V2500-D5 SERIES NACELLE SERVICE BULLETIN

This document transmits the Initial Issue of Service Bulletin NV2500-71-0287

MODIFICATION SERVICE BULLETIN – NACELLE – PYLON – UPPER AND LOWER FITTINGS, THRUST
REVERSER – ADDITION OF ACTUATOR PIN RETAINER

Install the Opening Actuators in the Fittings - Before Modification
Figure 1 (sheet 1)

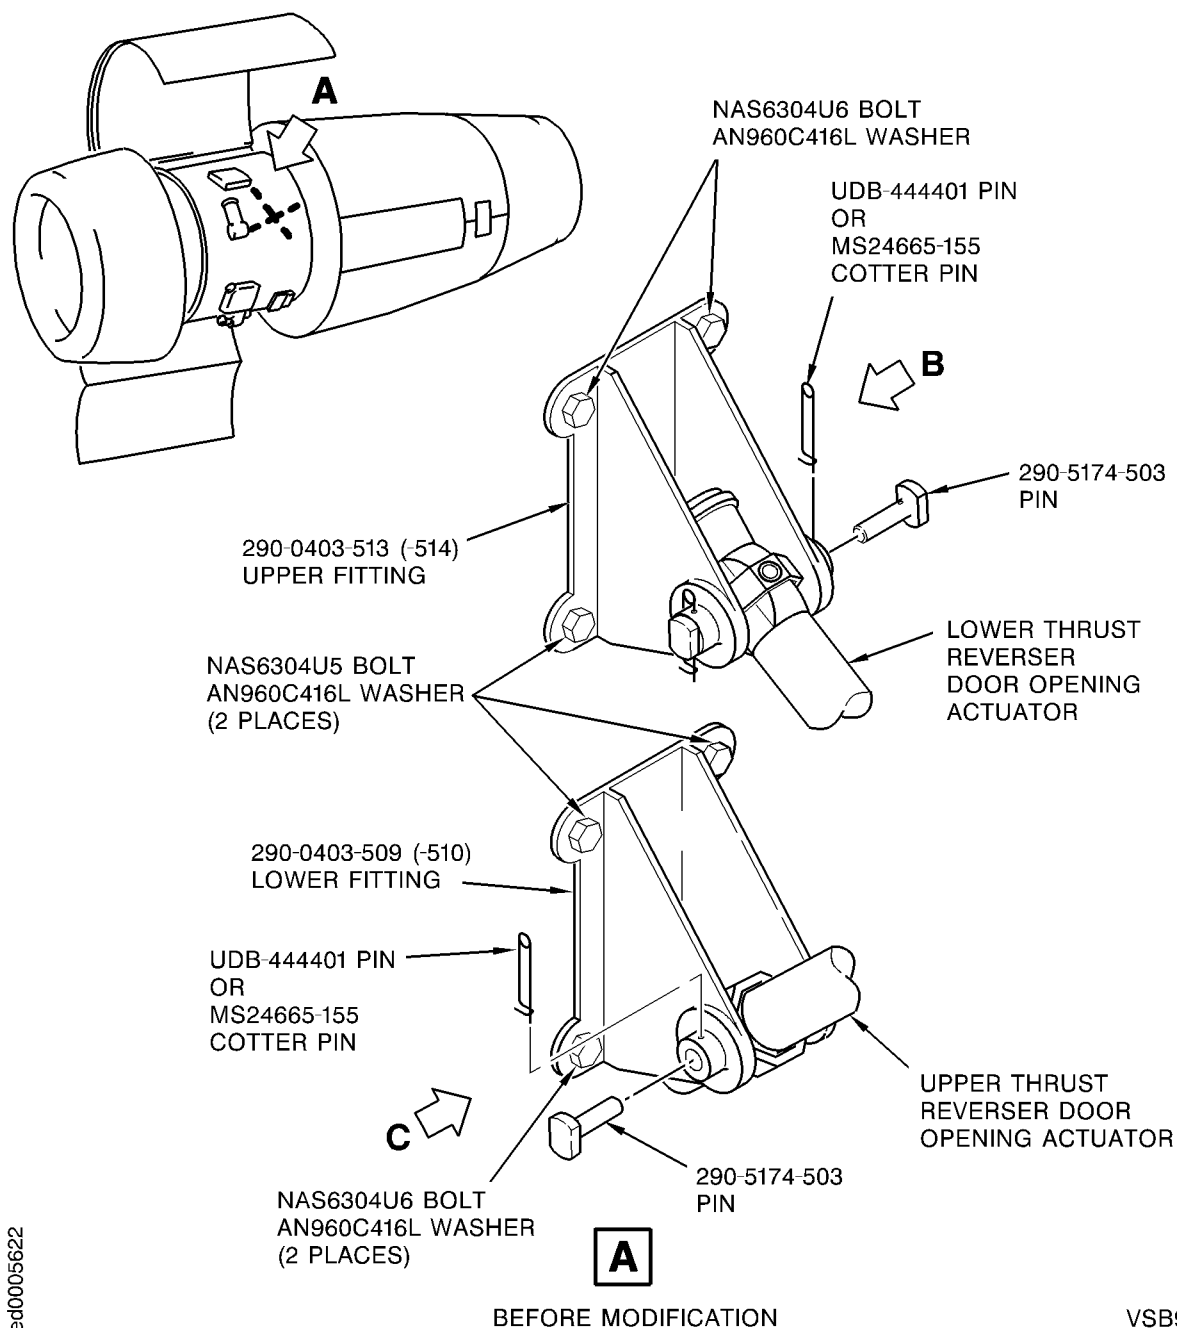
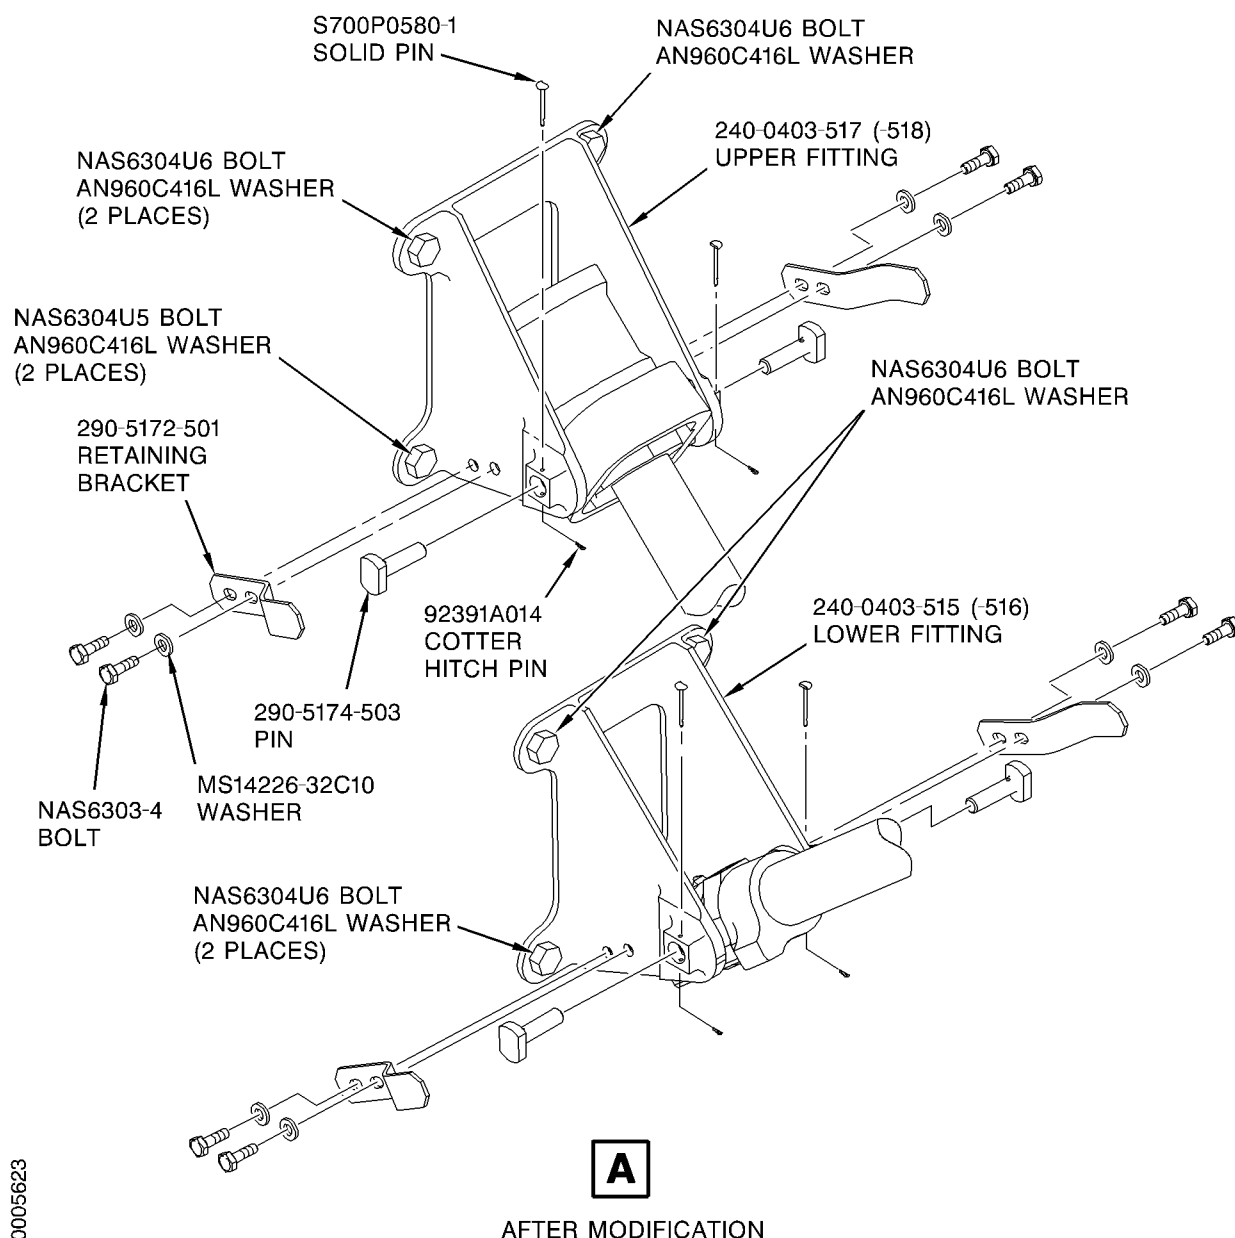
- (1) Open the upper and lower thrust reverser halves. Refer to the MD90 Aircraft Maintenance Manual, chapter 78-32-00, Page Block 201.
- (2) Remove the upper and lower thrust reverser half opening actuators. Refer to the MD90 Aircraft Maintenance Manual, Chapter 78-35-11, Page Block 401. Discard the hardware that attaches the actuators to the upper and lower fittings except the 290-5174-503 pins. Refer to Figure 1 (sheet 1).

B. Remove the Opening Actuator Upper and Lower Fittings. Refer to Figure 1 (sheet 1).

- (1) Remove the NAS6304U6 bolts, NAS6304U5 bolts, AN960C416L washers and the 290-0403-513 (-514) upper fitting from the pylon.
- (2) Remove the NAS6304U6 bolts, NAS6304U5 bolts, AN960C416L washers and the 290-0403-509 (-510) lower fitting from the pylon.

- D. Install the Opening Actuator Upper and Lower Fittings. Refer to Figure 1 (sheet 2).

- (1) Install the AN960C416L washers, NAS6304U6 bolts, NAS6304U5 bolts, and the 290-0403-517 (-518) upper fitting on the pylon. Torque the bolts to 63-70 inlbs (7-8 Nm).
- (2) Install the AN960C416L washers, NAS6304U6 bolts, NAS6304U5 bolts, and the 290-0403-515 (-516) lower fitting on the pylon. Torque the bolts to 63-70 inlbs (7-8 Nm).

- E. Post-requisite Instructions. Refer to Figure 1 (sheet 2).

- (1) Install the upper and lower thrust reverser half opening actuators but do not install the hardware that attaches the actuators to the upper and lower fittings. Refer to the MD90 Aircraft Maintenance Manual, Chapter 78-35-11, Page Block 401.
- (2) Install the solid pins and the cotter hitch pins.
- (3) Install the actuator pin retainers on the fittings with the bolts and washers. Torque the bolts to 30-35 inlbs (3,39-3,96 Nm).
- (4) Close the upper and lower thrust reverser halves. Refer to the MD90 Aircraft Maintenance Manual, chapter 78-32-00, Page Block 201.

Modify the Upper Opening Actuator Fitting
Figure 1 (sheet 3)

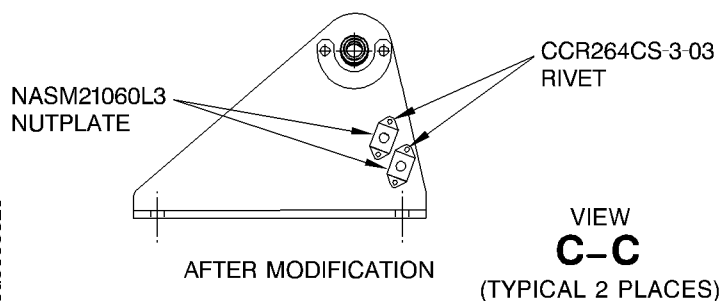
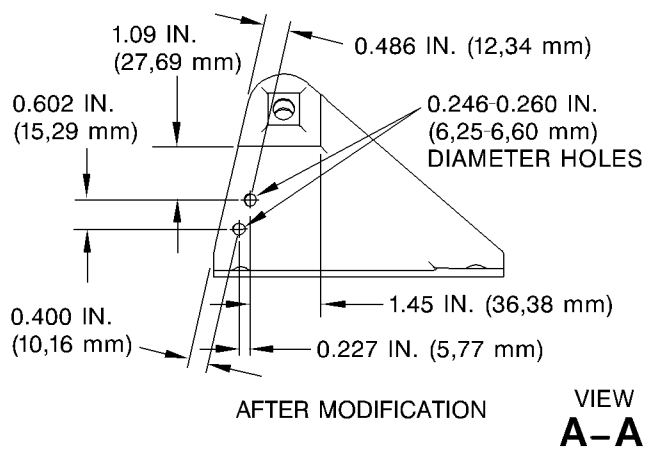
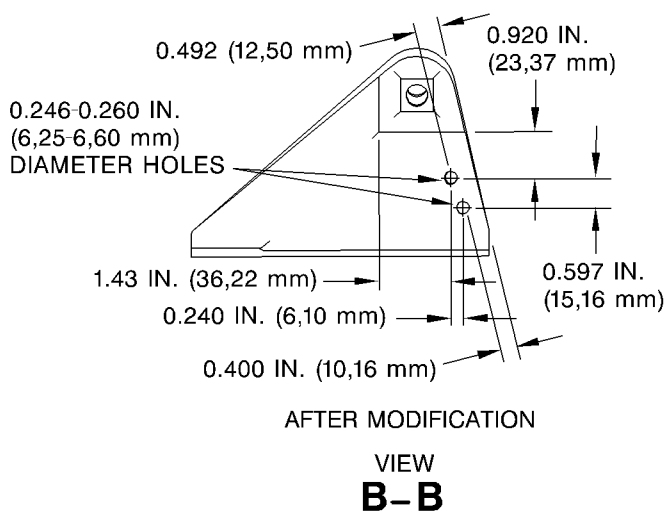
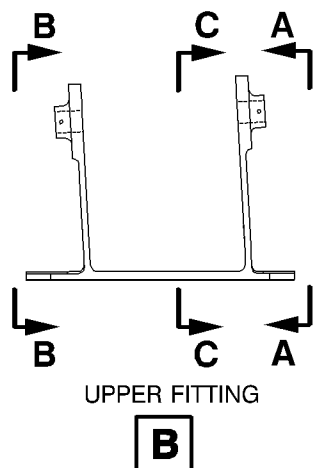
C. Modify the Opening Actuator Upper and Lower Fittings. Refer to Figure 1 (sheets 3 and 4).

- (1) Clean the fittings with a lint free cloth (CoMat 02-099) made moist with solvent (CoMat 01-438). Wipe the surfaces dry before the surfaces become dry.
- (2) Make the nutplate attach fastener and bolt holes in the fittings.

- (3) Mix the primer (CoMat 07-140), catalyst (CoMat 07-139), and thinner (CoMat 07-144). Refer to the manufacturer's instructions.
- (4) Install the nutplates on the fittings with the rivets. Wet install the rivets with primer.
- (5) Re-identify the upper and lower fittings as indicated below. Use a rubber stamp and ink (CoMat 06-075). Refer to the IAE V2500 Standard Practices/Processes Manual, Chapter 70-09-00.

OLD PART NUMBER	NEW PART NUMBER
290-0403-509	290-0403-515
290-0403-510	290-0403-516
290-0403-513	290-0403-517
290-0403-514	290-0403-518
